RECEIPT DATE: 07/26/2021 **ONSITE SEWAGE DISPOSAL SYSTEM** P 569622

PROPERTY ADDRESS: 1433 Underwood Road, Sykesville, MD 21784

SUBDIVISION: Rizk Property LOT: 4 TAX ID: 03-601464

The following comments pertain to the review of the OSDS Plan for 1433 Underwood Road (Lot 4):

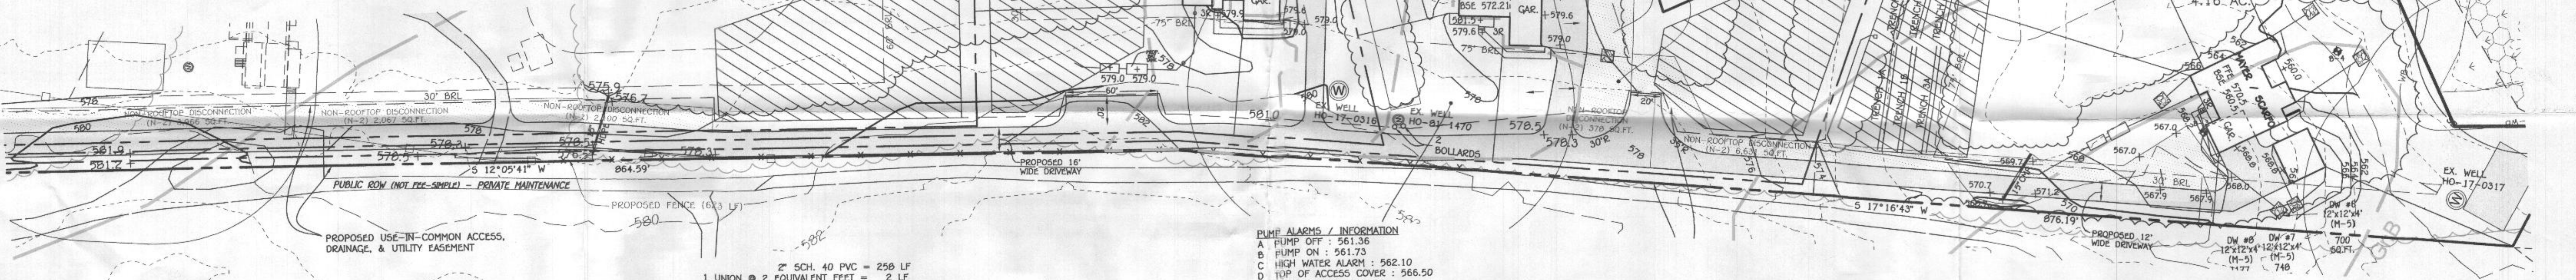
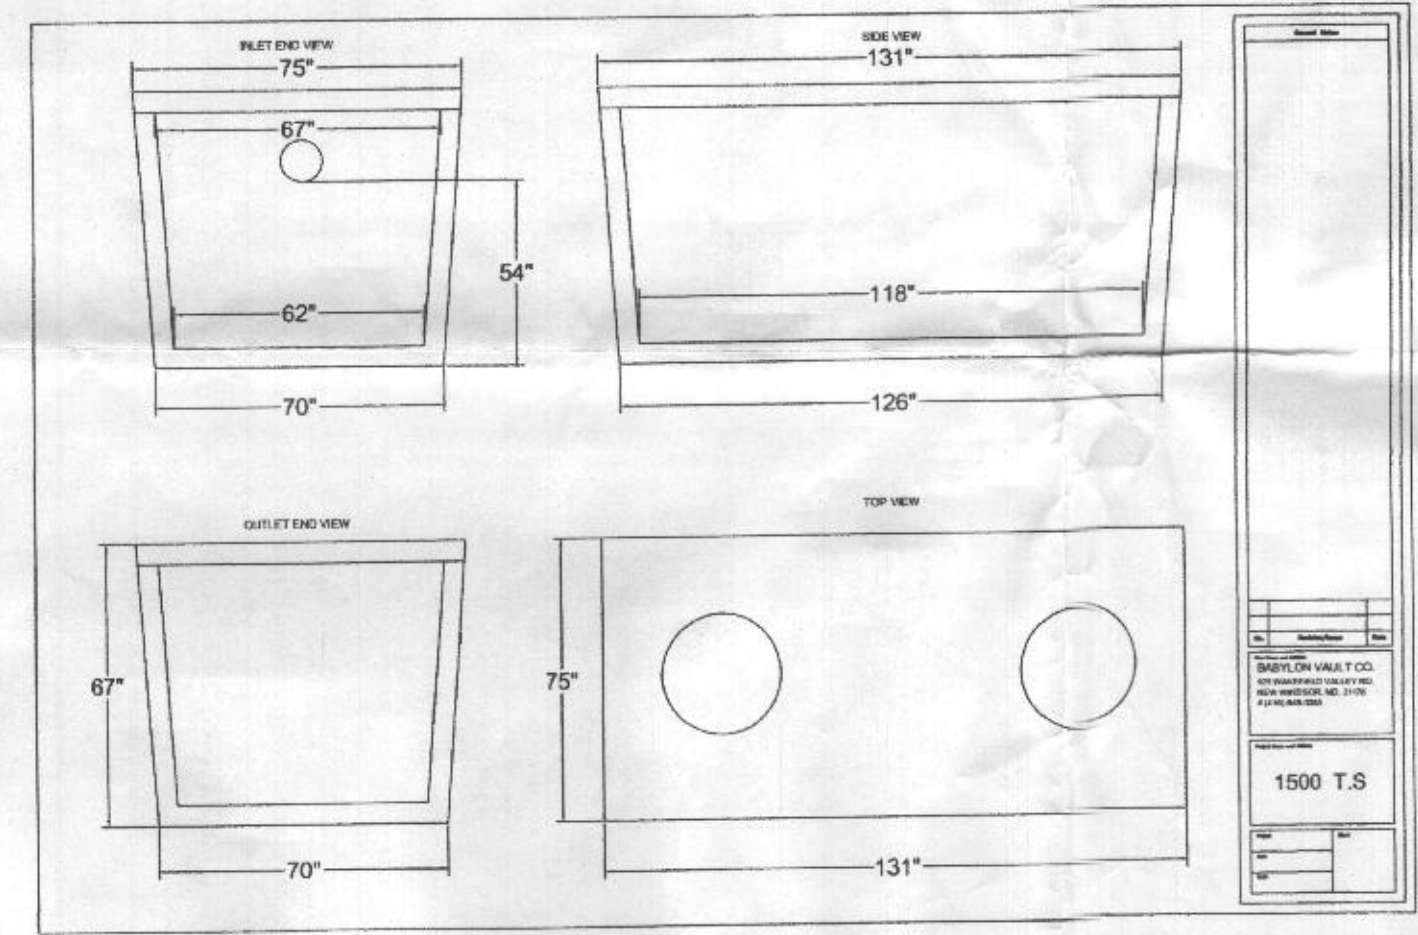
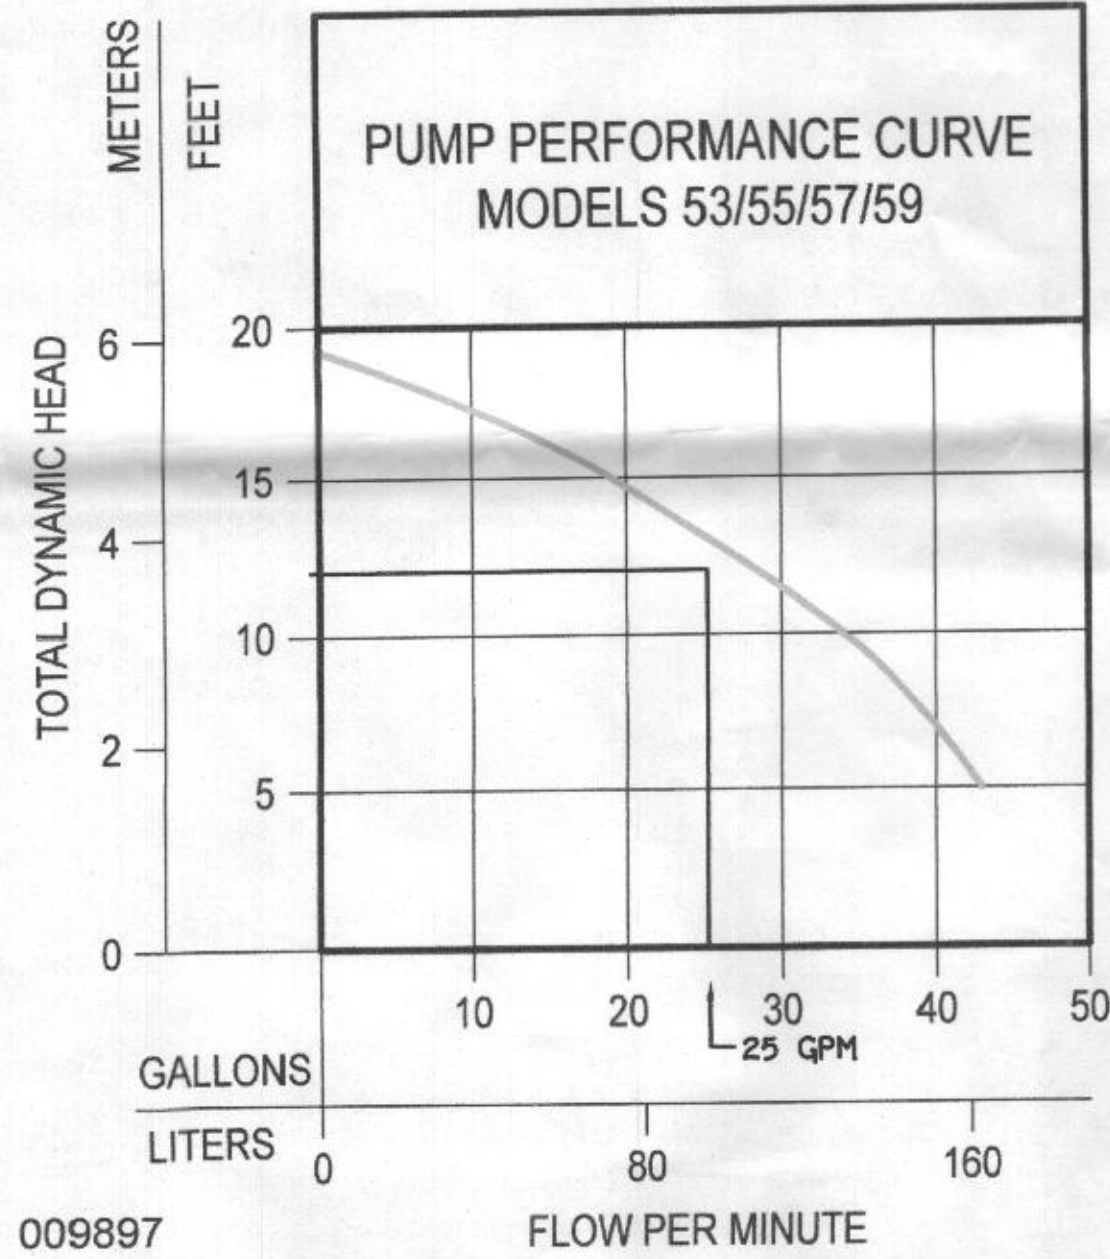
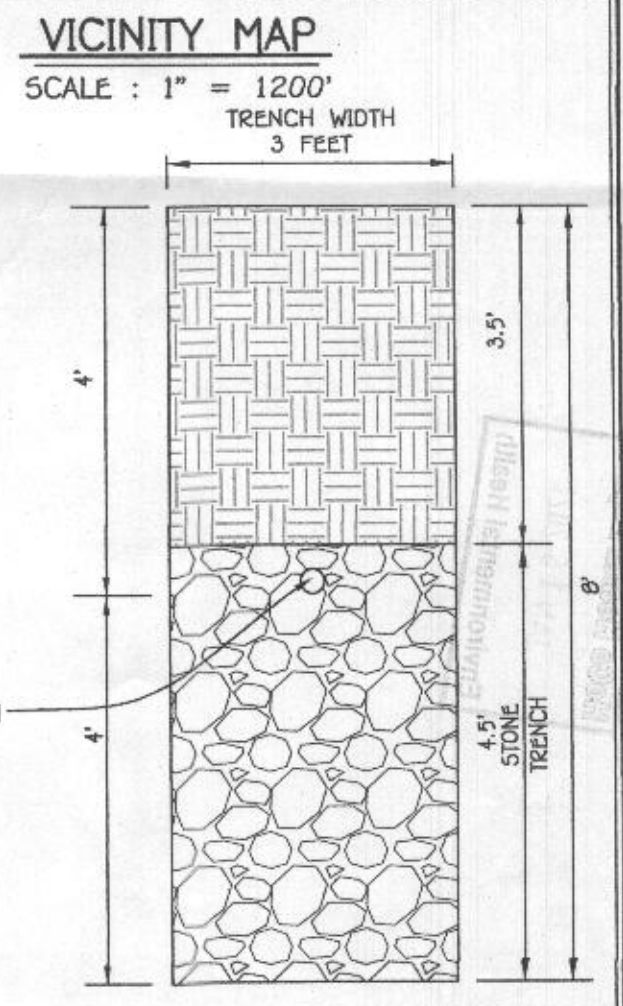
#5 Correction. No sleeve required on septic line if it's not going under the driveway, but still show cross section detail.

1. Correct elevation #'s on "Septic Profile" starting at 569 ^. Adjust elevation #'s on plan as needed.
2. Raise up tanks but no shallower than 6 inches from grade while maintaining 2% fall and raise up d-box and trench inverts but no shallower than 18 inches from grade. Adjust, "Initial Trench Detail" as needed.
3. Relocate d-box to top center of sewage disposal area. Adjust calculations as needed.
4. Show emergency storage calculation for 1 day design flow.
5. Show cross section detail of septic line at driveway culvert on Septic Profile. Show sleeve on septic line.
6. The floor plan shows 5 BRs and an unfinished basement with a F.B.R.I. The basement has the potential for one or more bedrooms upon conversion to finished living space. It is recommended that the septic system is sized for one additional bedroom (if possible).

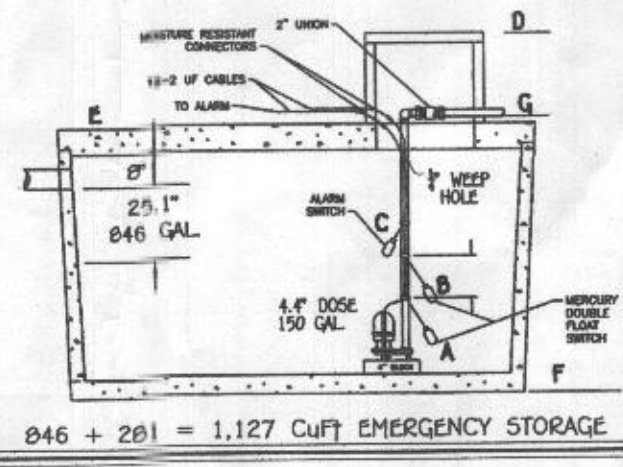
Where did you find the friction loss #'s for the fittings used on this plan? As I was saying to Stephanie the other day, we would like engineers to use the charts out of the sand mound manual. If you want to use a different chart(s), then you'll need to specify a pipe manufacturer on your design and those #'s should come from that manufacturer.
